CORRIGENDUM-4

Ref: TPCODL/P&S/72/2020-21/Corrigendum/04

Sub: Modification to BoQ and Addition/Modification of Tender number TPCODL/P&S/72/2020-21 Reference Document- Our Tender number TPCODL/P&S/72/2020-21 for Rate Contract for 11kV and 1.1 kV associated works (Construction / Augmentation) all over TPCODL area for releasing new HT < connection & other misc. Distribution electrical works

ANNEXURE-B- Addition / modifications to Tender specification & Drawings

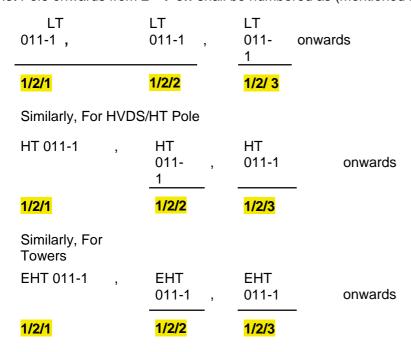
Case 2: In case two T-off from one pole are there then two different T-off will be numbered separately. e.g. For

LT Pole/FP/SP, 1st pole onwards from 1st T-off shall be numbered as (mentioned in bold)

Similarly, For HVDS/HT Pole

Similarly, For Towers

Ist Pole onwards from 2nd T-off shall be numbered as (mentioned in bold)
